# Hampden Rd Master Plan and Hampden/Broughton intersection papers

comment by Peter Egan

**Document – Artarmon Local Centre Public Domain Master Plan** – comment follows that on the intersection document

## **Document – Hampden Road/ Broughton Road Intersection - Willoughby Council Intersection Options Assessment and Feasibility Study by GTA**

Figure 3.15: Pedestrian crossing volumes during AM/ PM and Saturday traffic peak

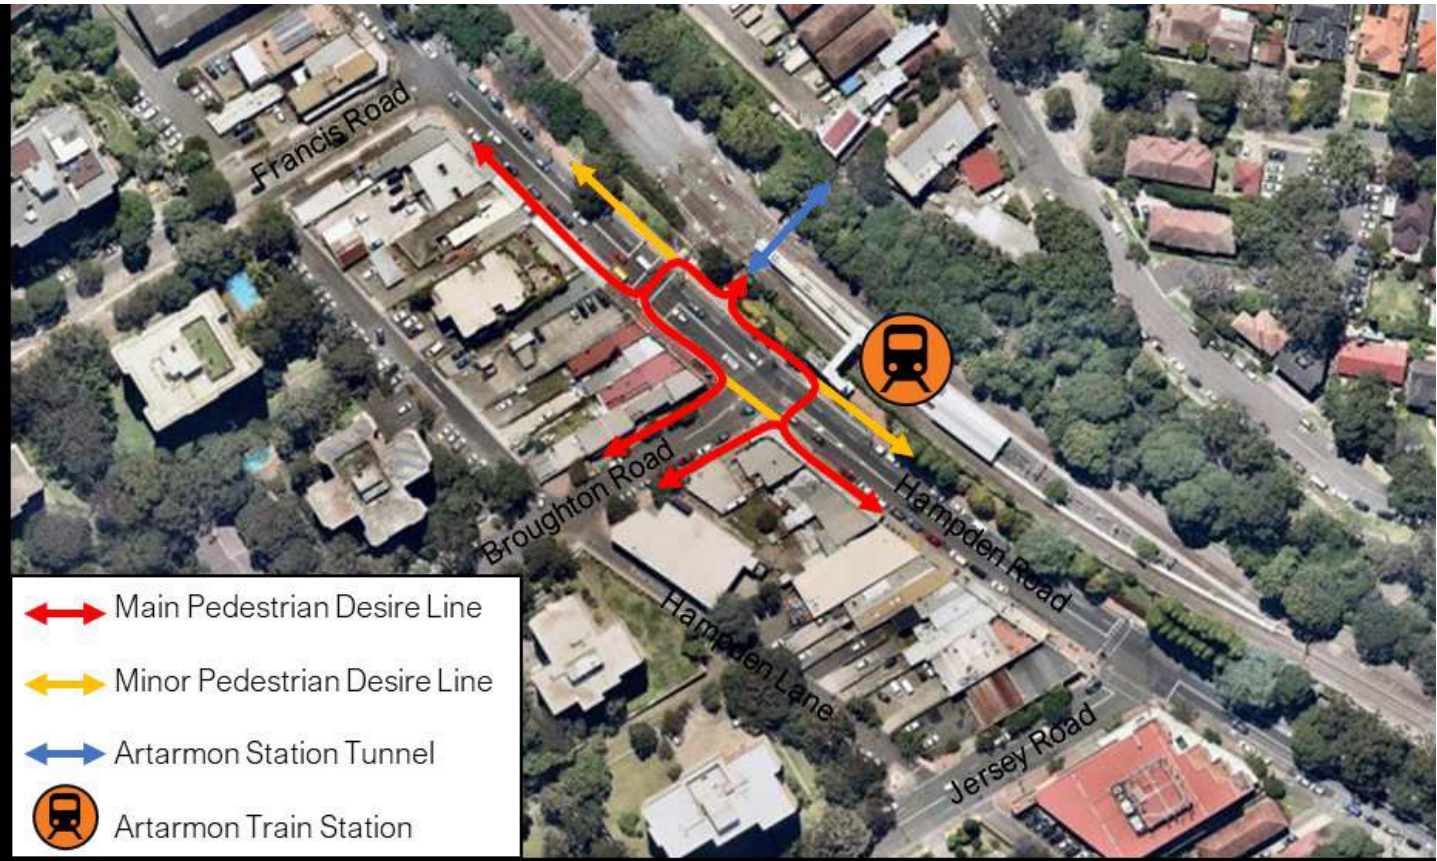
Again, the data has not been presented in a usable format. Pedestrian data also appears in Appendix C (SIDRA modelling).

The data in Figure 3.15 has not been related to that in Table 3.4.

Many people visit the shops (particularly the food shops) before and after work. Broughton Rd pedestrian crossings include people shopping and accessing the station on weekdays.

The high pedestrian numbers crossing Broughton Rd on weekends reflects more people having time to visit more shops. GTA is wrong in saying the desire line across Broughton Rd is independent of weekday commuting.

Figure 3.16: Existing Pedestrian Desire Lines

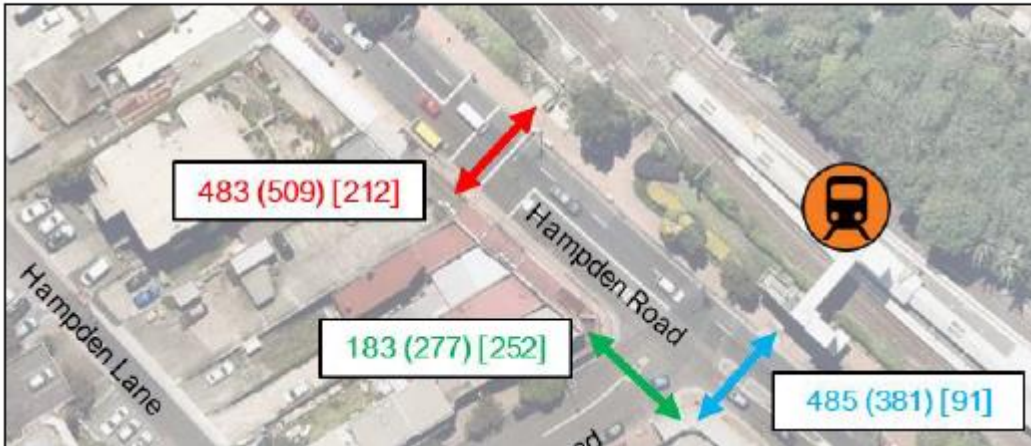
The advice accords with local experience. The pedestrian flows presented in Figure 3.16 (over page) appear representative of those observed by local residents. As it is legal to cross a road at any time when more that 20 metres from a signalised crossing. Many people cross Hampden Rd during gaps in traffic.

**Report Figure 4.2: Redistribution of traffic within Artarmon Local Centre for option 3**

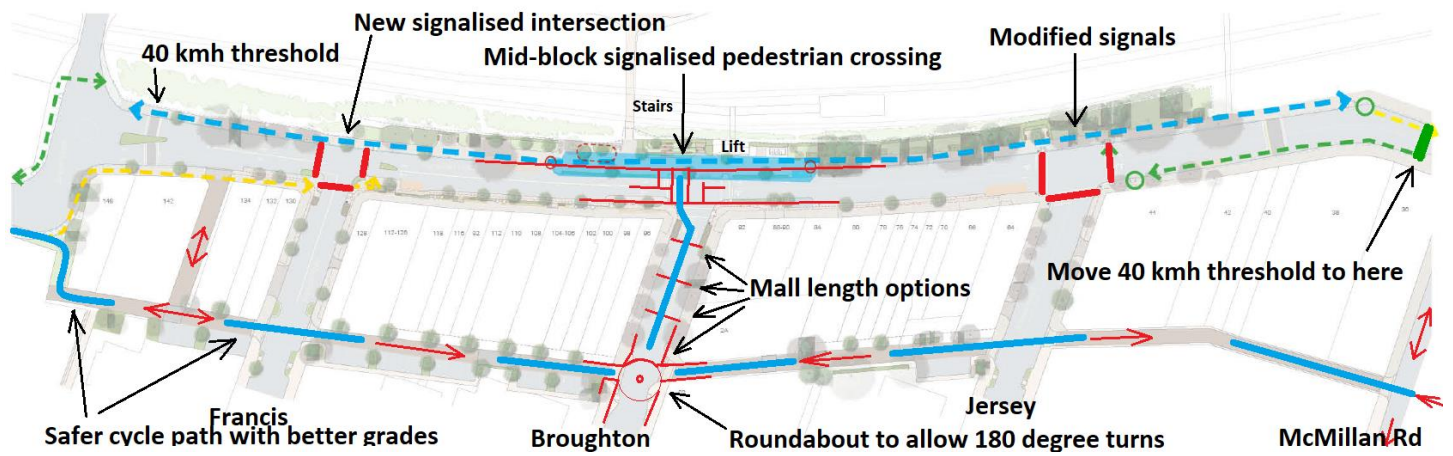
The reversal of traffic directions on Hampden Lane to southbound only between Francis Road and Broughton Road shouldn't be implemented in isolation and this would create a parallel southbound route on Hampden Lane and therefore encourage the use of this alternative route which is not suitable to accommodate additional traffic.

The section of Hampden Lane between Broughton Road and Jersey Road would also need to be reversed and Buller Road opened to be two way at the intersection of Broughton Road as this would result in being an alternative route.

To reduce traffic volumes on Hampden Road further understanding of the per cent of vehicles that are not accessing the local centre and therefore should be utilising the wider state road network needs to be investigated.

#### **Pedestrian/cycle underpass of Pacific Hwy**

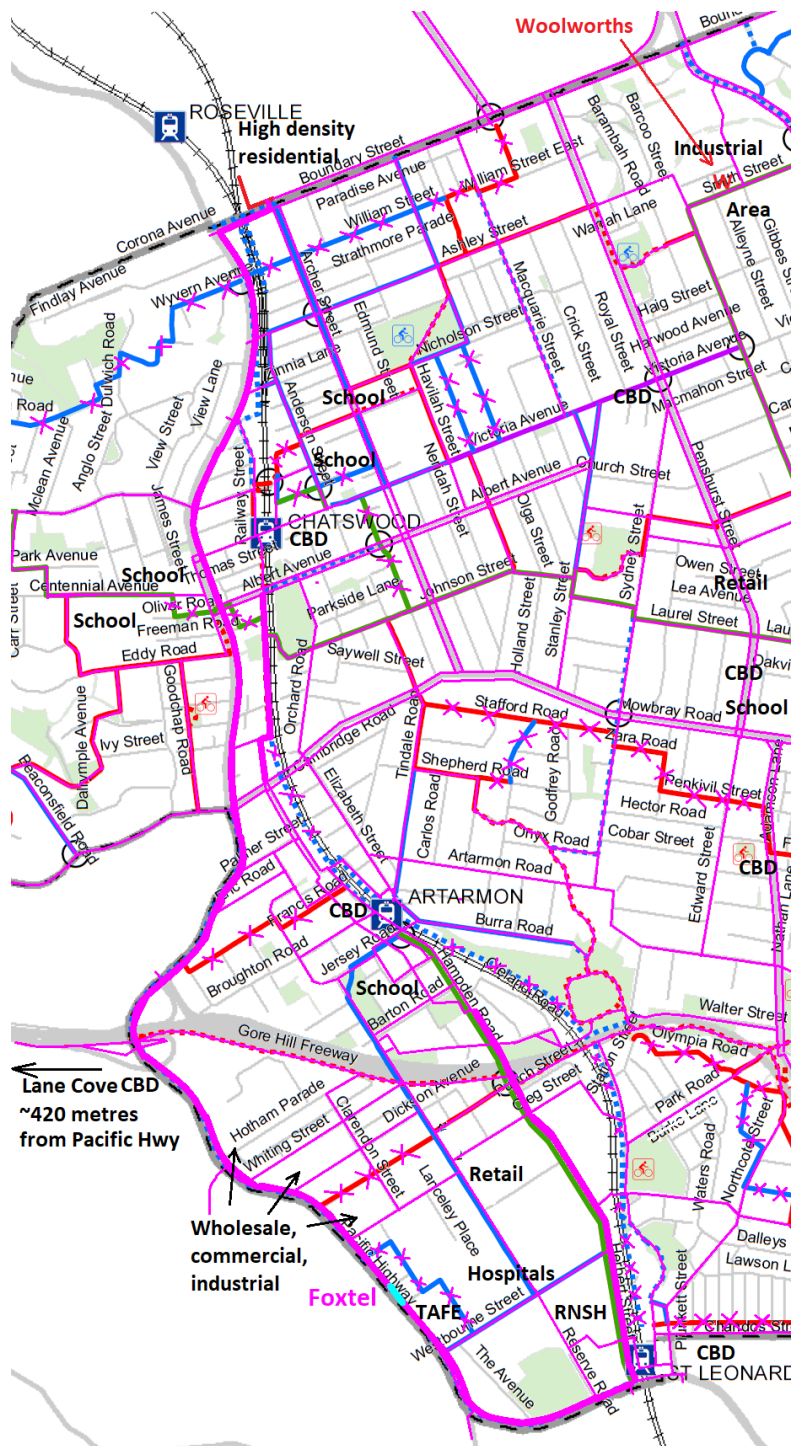
I suggest investigation of cycle/pedestrian underpass of Pacific Hwy via existing rail tunnel on eastern side.

**Figure 1 – Cycle routes for community consultation**

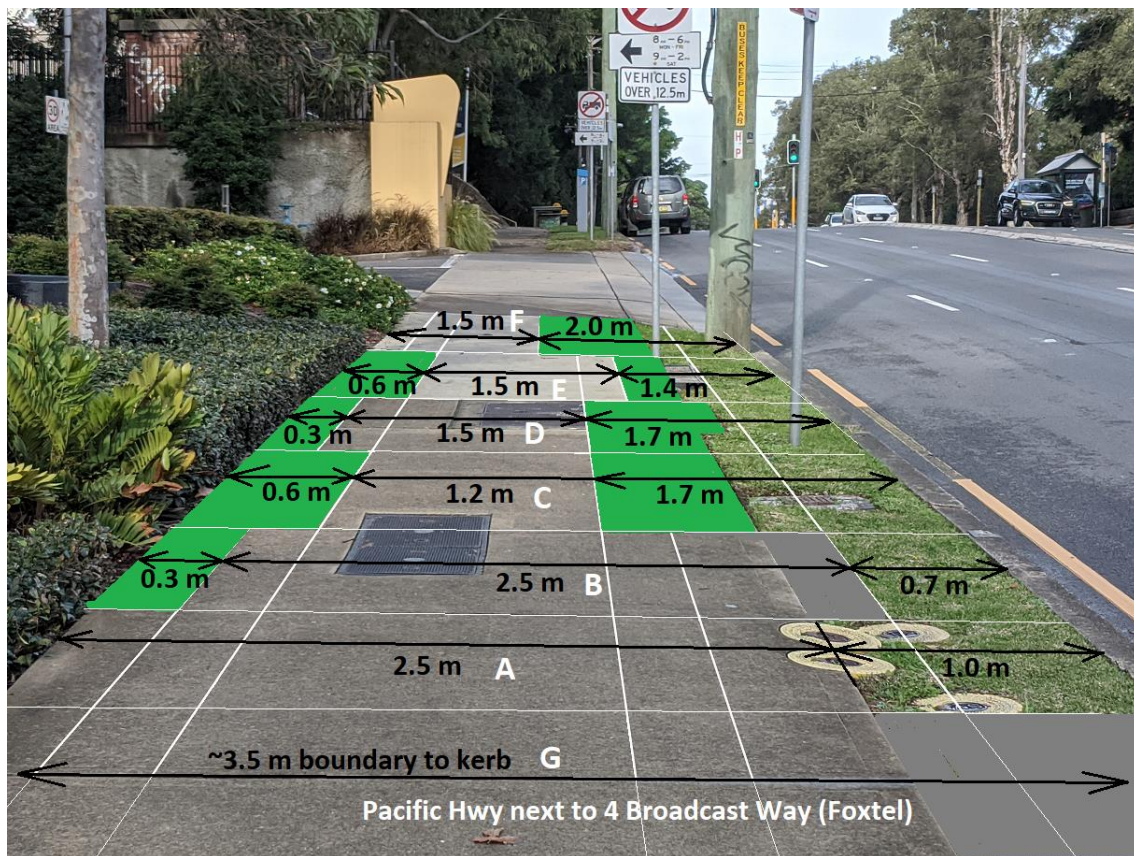
The present Willoughby cycle network, as drawn by GTA Consultants, is intended for fit experienced cyclists. Council should consult the community on a broader list of cycle routes partially illustrated in Figure 1. Generally, we need a shared pedestrian-cycle path along all busy roads, and other roads subject to circumstances. A key focus for consultation is the side of the road to get the shared path.

--- A Herbert St shared path (heavy pink line) should be implemented on the east side to link to the shared path beside the motorway at Punch St

--- All other streets in the LGA should be studied for a shared path on one footpath based on traffic volumes (and indicator of demand and on-road safety), the appropriate side of street based on many factors, coverage of neighbourhoods with shared paths.

**Figure 3 – Cycling on the Pacific Hwy roadway and footpath**

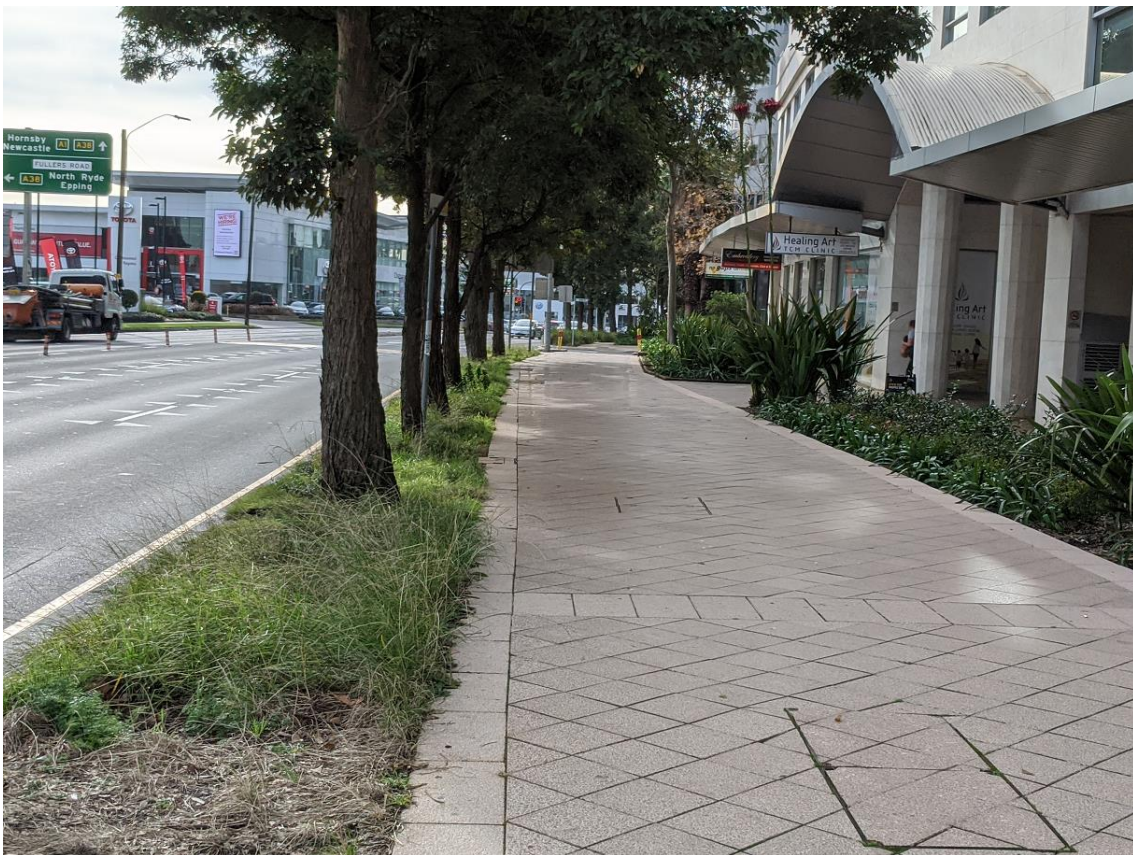
Note cyclists and grass verge separator

Figure 8 – Greater Sydney Principal Bicycle Network

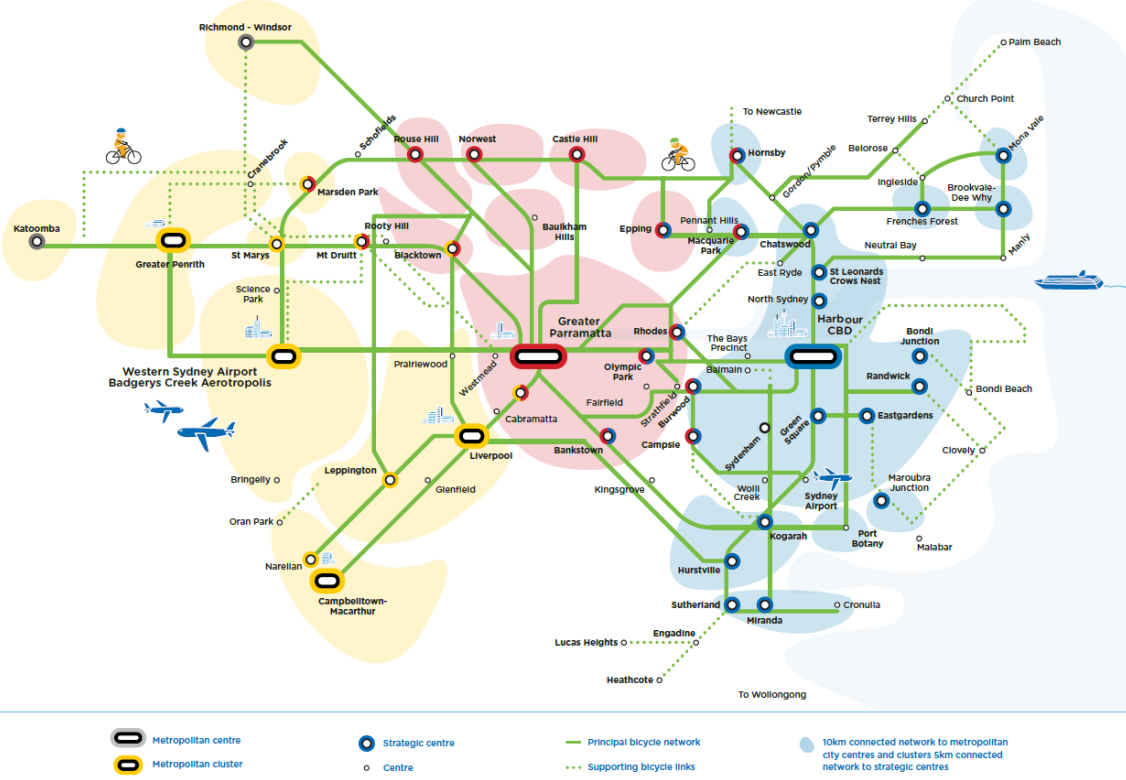
GTA Figure 1.1 is based on TfNSW's Future transport Strategy 2056 (version from the 2056 Strategy in Figure 8 below). The figure indicates a Tier 1 path from St Leonards to Chatswood. It does not indicate whether the route also serves Lane Cove or Artarmon. GTA do not provide any analysis of a route via the Pacific Hwy which has a direct link to Lane Cove.

Figure 9 – Figure 2.14 from the Castle Cove to Chatswood report by Jacobs

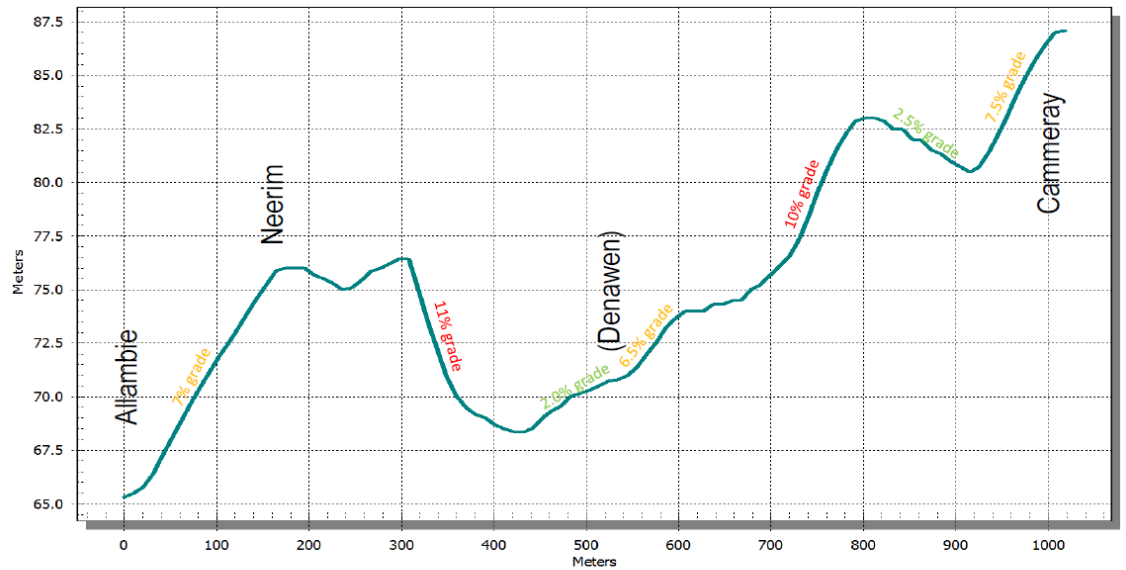
I request a route selection report with information similar to the Castle Cove to High St Chatswood Bicycle Route Development report by Jacobs, dated 25 May 2019. This report provides some good information to inform bike route selection. Figure 2.14 from the report (Figure 9 below) is an example of the information required.

**Figure 10 – relative locations of North Shore Line track and parallel cyclepath**

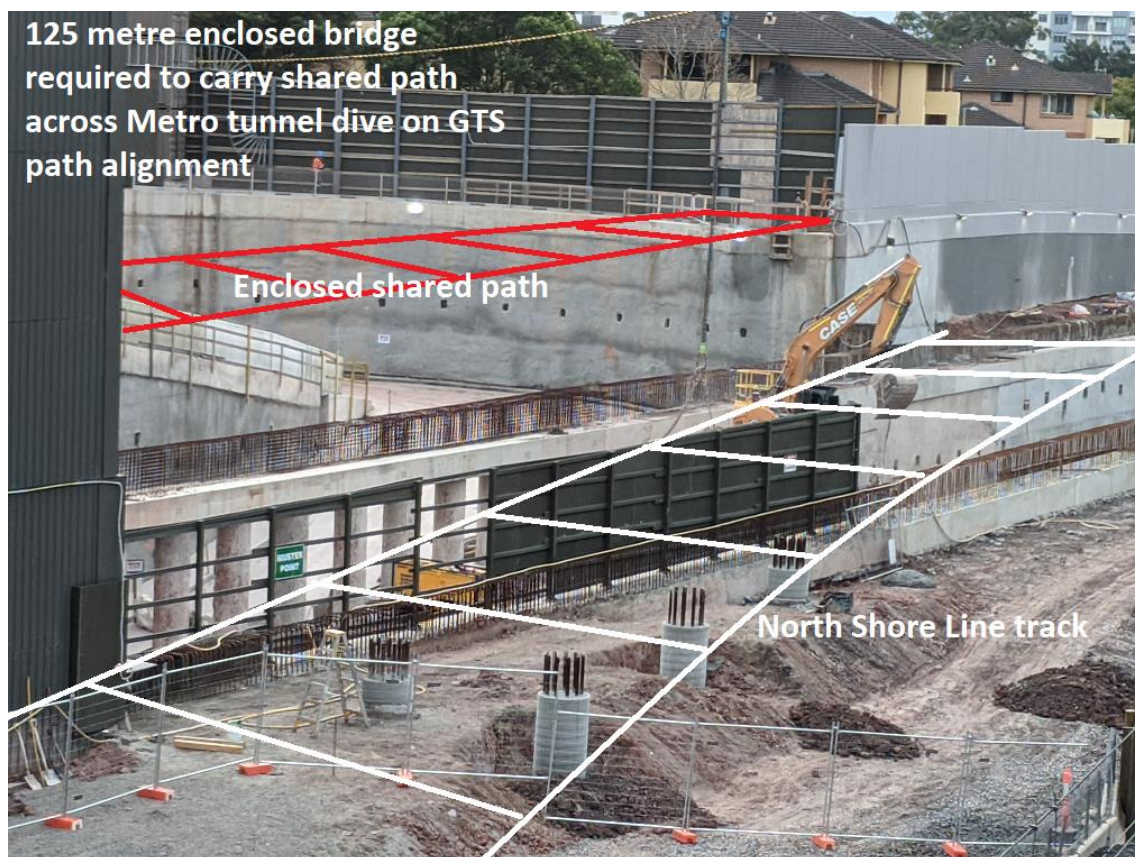
GTA's preferred Tier 1 route between Chatswood (Frank Channon Walk) and St Leonards is via the rail corridor due to the gentle grades of the rail tracks. Rail corridor space allocations make this route extremely difficult to achieve. The relative locations of the North Shore Line track and a parallel cycle path is illustrated in Figure 10 – the latter requires a 125-metre enclosed bridge over the Sydney Metro dive.

**Figure 13 – 115 Hampden Rd's 2.3 metre intrusion into the footpath space**

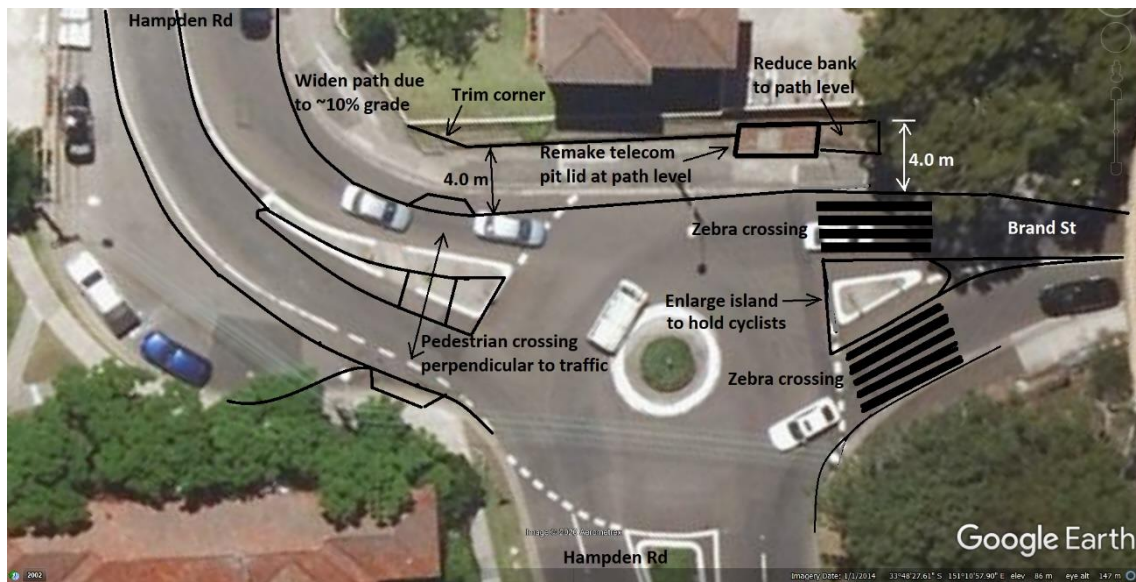
The NSW government's Six.Maps property boundary webmap shows 115 Hampden Rd having the same property boundary alignment as neighbouring properties (Figure 12). However, the residents still have use of the 2.3 metre-wide strip excised from the property (Figure 13).

**Figure 14 – proposed rearrangement of Brand St-Hampden Rd intersection**

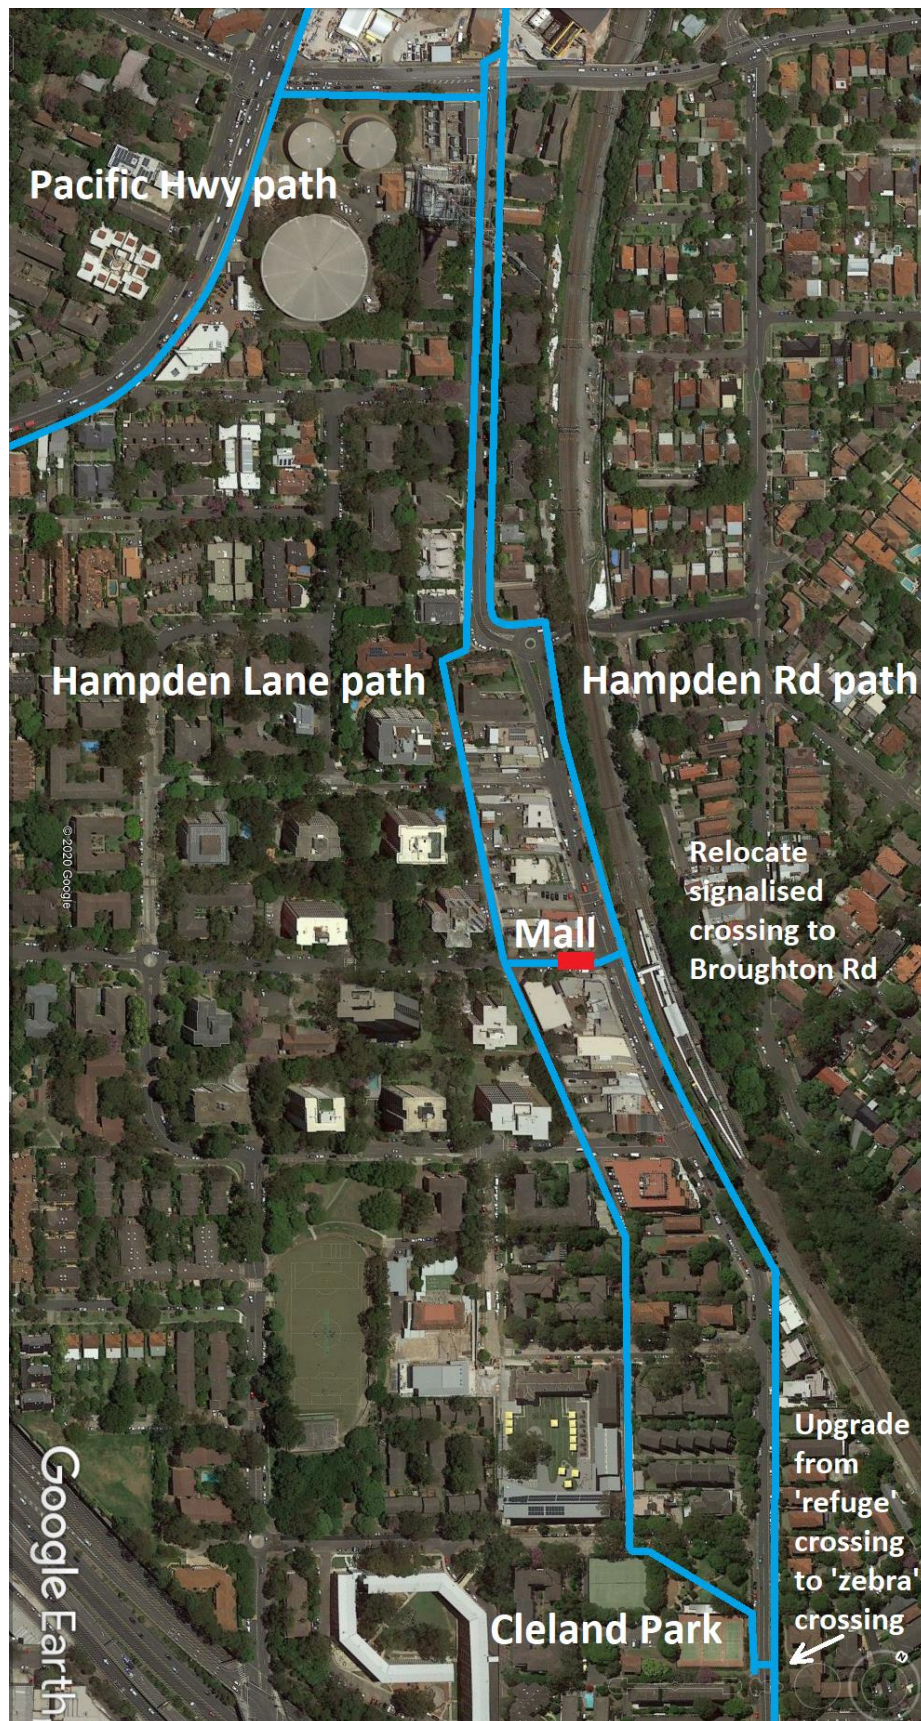
--- If the path is fully on the east side of Hampden Rd, that Brand St be addressed as shown in Figure 14.

A two-part zebra crossing (Figure 14) with a wide median is much less disruptive to motorists, pedestrians and cyclists than traffic lights.

A two-part zebra crossing with a wide median is much less disruptive to motorists, pedestrians and cyclists than traffic lights which would need to operate in unison with the other sets of Hampden Rd traffic lights, and could not be operated on an on-demand basis.
